APPEAL LETTER

1054 University Avenue – CUP 2020-001

Re: 1054 University Ave; Conditional Use Permit 2020-001 Appeal

TITLE: **CONDITIONAL USE PERMIT 2020-001; REQUEST FOR RESIDENTIAL DESIGN REVIEW TO CONVERT 965 SQUARE FEET OF AN EXISTING 1,099 ATTIC INTO A SECOND STORY ADDITION WITHIN AN EXISTING SINGLE-FAMILY DWELLING UNIT LOCATED AT 1054 UNIVERSITY AVENUE IN THE R-L-5.5 (RESIDENTIAL LOW DENSITY) ZONING DISTRICT**

Sheet Title
**NEW ATTIC FLOOR PLAN
ROOF PLAN**

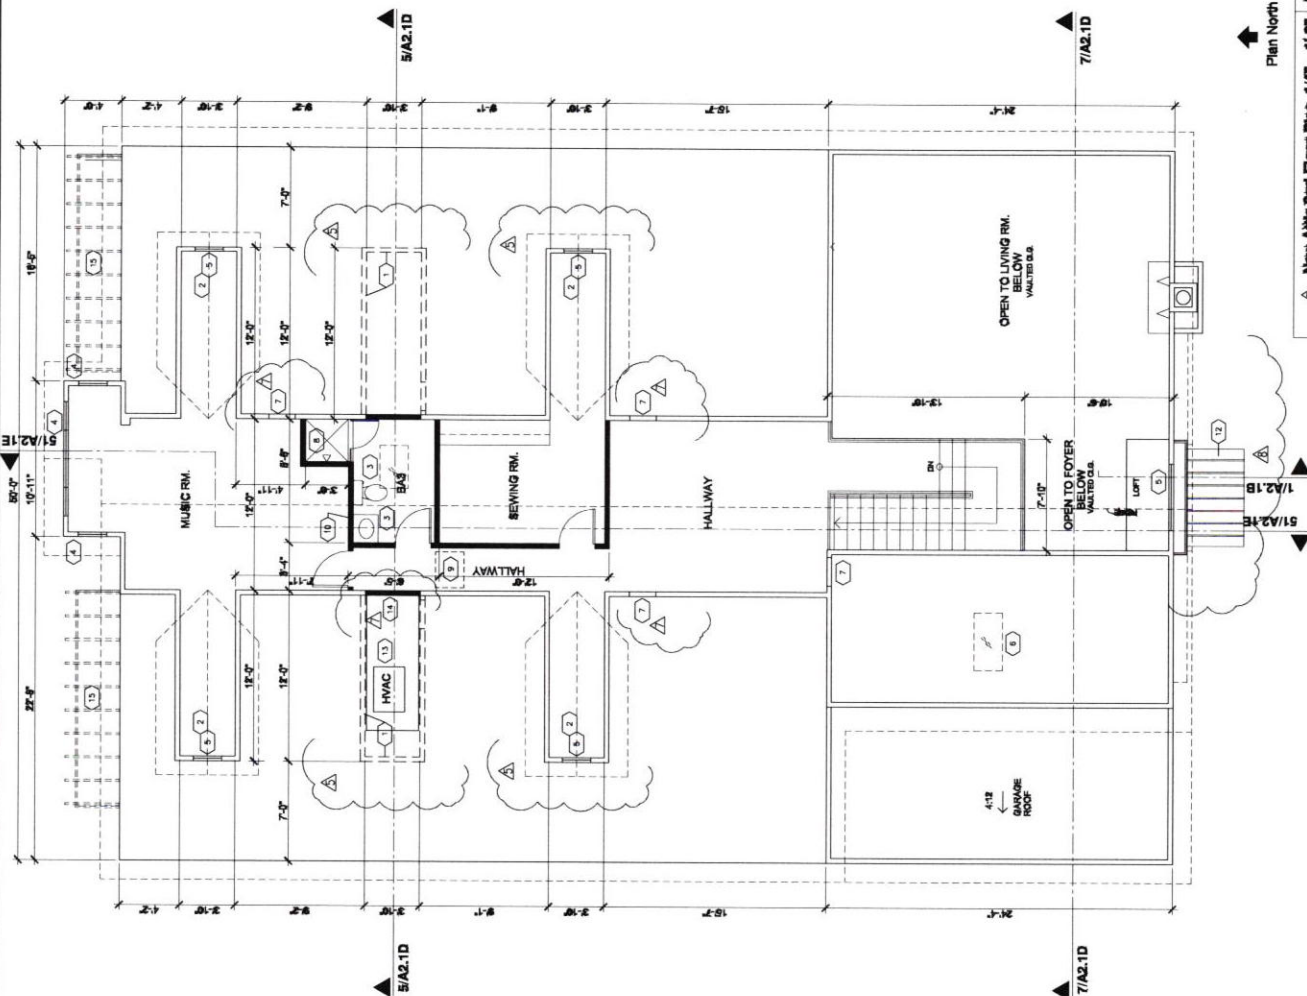
The Planning Commission requested the existing exterior front façade of the house, where there is an the existing window and high ceiling over the entry foyer and living room, be removed and the front wall of upper area of the home setback approximately 8 feet, completely redesigning the already existing City approved front façade.

While the Applicant agreed to add stone veneer around the main entry door, extend the copper metal roof porch over the front door, add decorative steel grill the under the high ceiling window facing the street, and add wood corbels to the copper roof overhand, as shown on **Exhibit D**, the Planning Commission was unwilling to approve the permit unless the front wall above the front portion of the house where the window and balcony were located was removed and the front wall set back approximately 8 feet.

The Applicant declined this request given (1) the fact the high pitched roof design was already approved by the City; (2) the attic conversion was making no change to the exterior façade; and (3) the area that the Planning Commission wanted removed, is in fact an existing open high ceiling area above the living room and foyer area and not part of the attic conversion.

Below is the January 21, 2021 rendering with copper seam metal roof porch with copper columns extended into front yard setback.

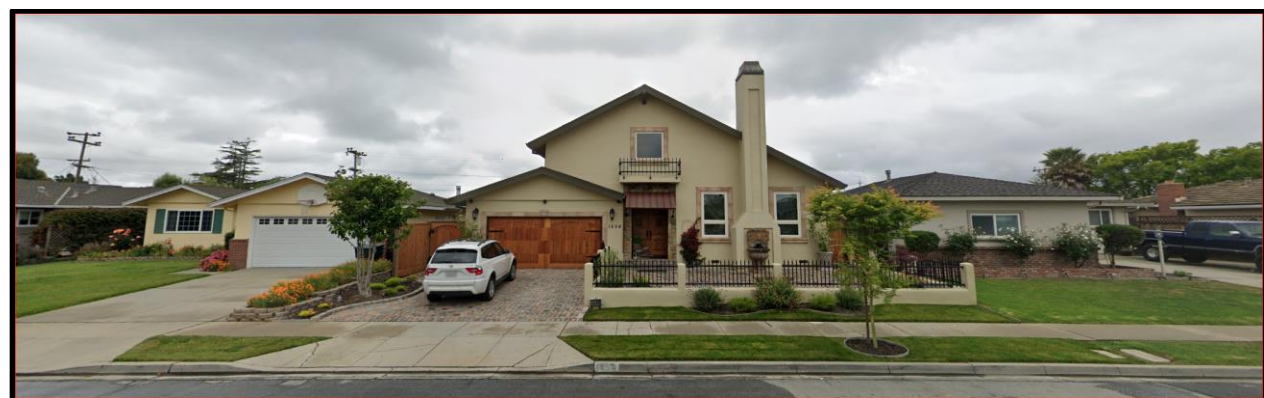
Analysis: Adding stone veneer around main entry door, a copper seam metal roof porch with copper columns over main entry door, and decorative steel grill and wood corbels under attic window facing the street appears not to address the Planning Commission's direction to minimize the scale and bulk of the second story addition and/or address articulation opportunities.
